Subject: Submittal of Supplemental Information for the MAGNASTOR System  
Application (TAC No. L23764)

Docket No. 72-1031

**List of SAR Changes for the  
MAGNASTOR Storage System, Revision 06A,  
in Response to the  
NRC/NAC Meeting on 12/8/05 &  
Subsequent NRC/NAC Conference Calls**

# **List of Drawing Changes for the MAGNASTOR Storage System, Revision 06A**

Figure 4.1-1 Definition of the Preferential Loading Pattern for PWR Fuel

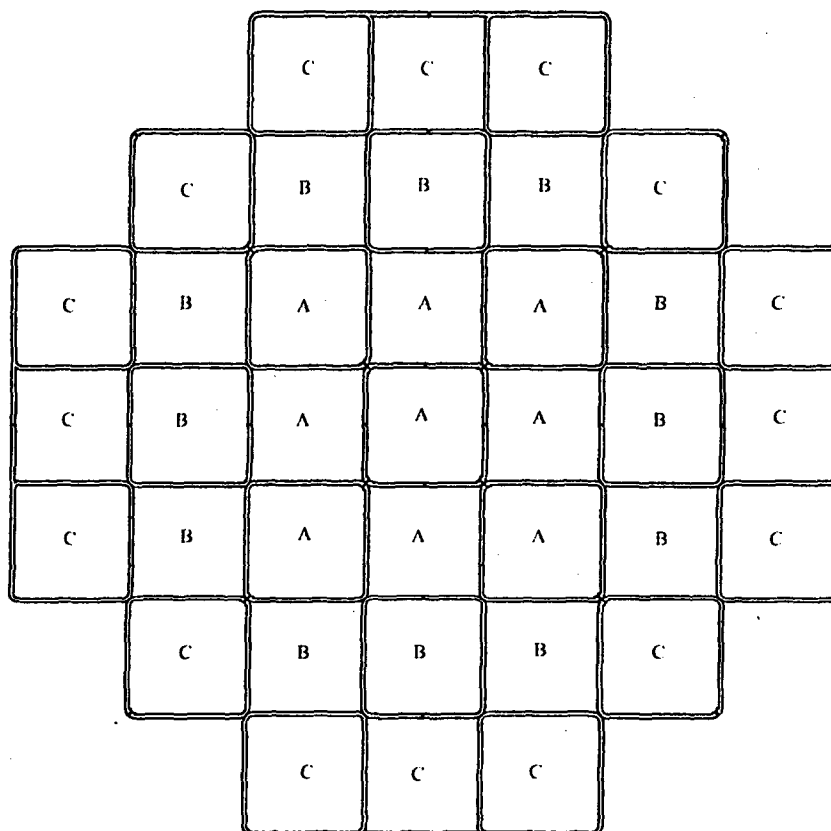
Chapter/ Page/ Figure/ Table	Description of Change
<b>Note:</b> The affected Chapter Table of Contents, List of Figures and List of Tables have been revised accordingly to reflect the list of changes detailed below.	
<b>Chapter 1</b>	
Page 1.8-1	Changed Drawing 71160-585 to Revision 4
Appendix 1-A, Pages A-1 thru A-3	Added Appendix 1-A, MAGNASTOR FUEL DATA, as requested by the NRC
<b>Chapter 2</b>	
Page 2.2-2	1 <sup>st</sup> full sentence – changed “37 kW” to “35.5 kW”; 3 <sup>rd</sup> full sentence – changed “1 kW/assembly” to “0.96 kW/assembly”
Page 2.2-3	1 <sup>st</sup> full sentence – changed “35.0 kW (average of 0.402 kW/assembly)” to “33.0 kW (average of 0.379 kW/assembly)”
Page 2.2-4, Figure 2.2-1	Information beneath figure – revised Heat Load column
Page 2.2-6, Table 2.2-1	Changed the Max Decay Heat (Watts) per Storage Location from “1,300” to “1,200” & added “Preferential”; added new last bullet beneath table

Figure 4.8.2-2 Three-Dimensional Fluent Model of a Fuel Assembly Grid

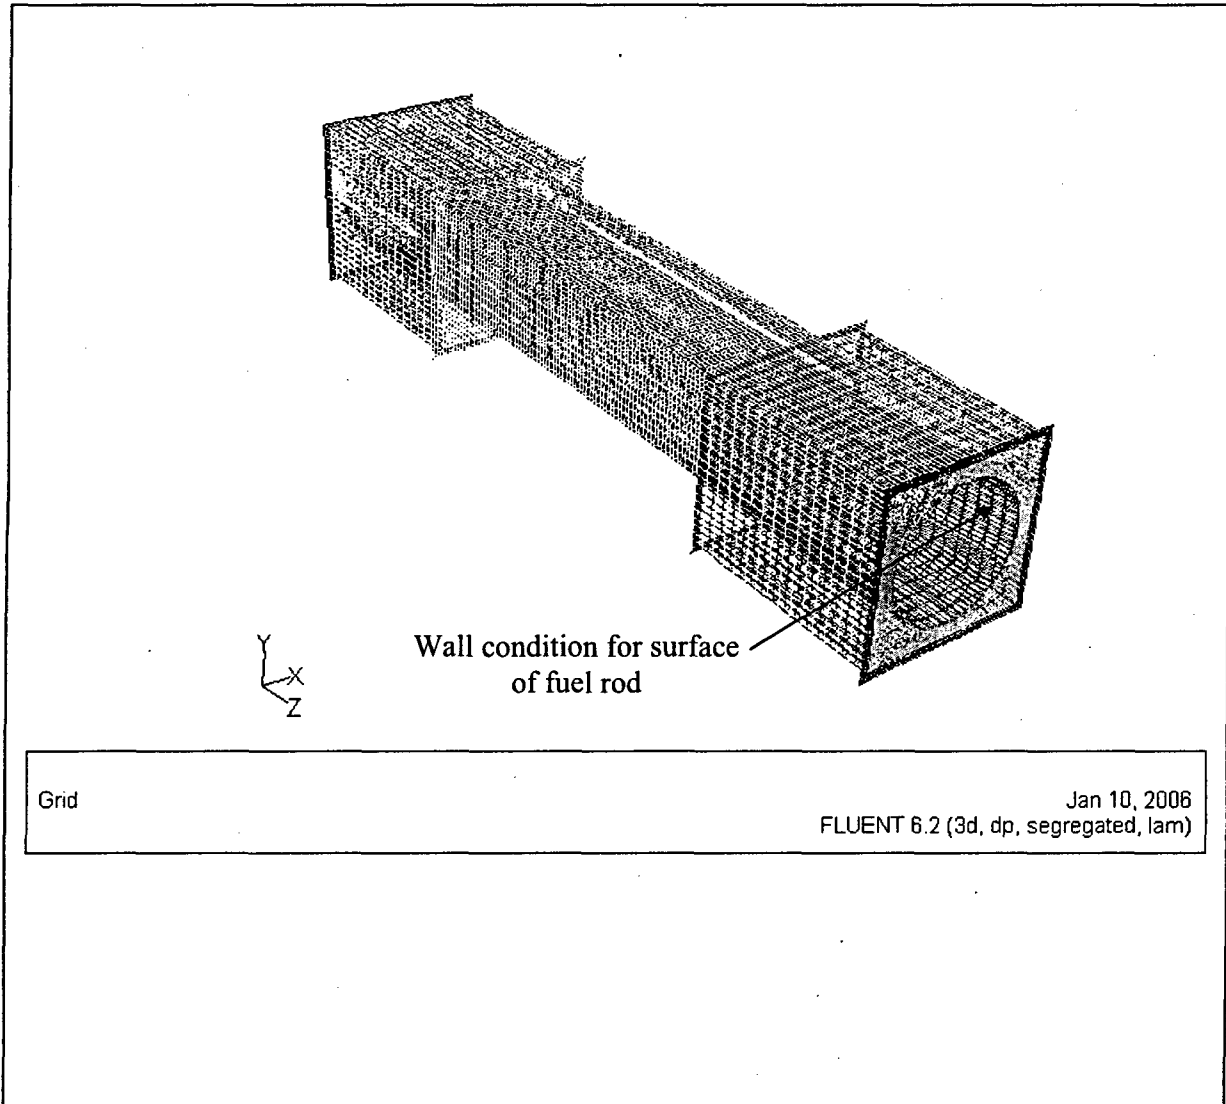
Page 4.8.2-4	Paragraph revised throughout
Page 4.8.2-6, Figure 4.8.2-2	Inserted revised figure
Page 4.8.2-7, Figure 4.8.2-3	Inserted revised figure
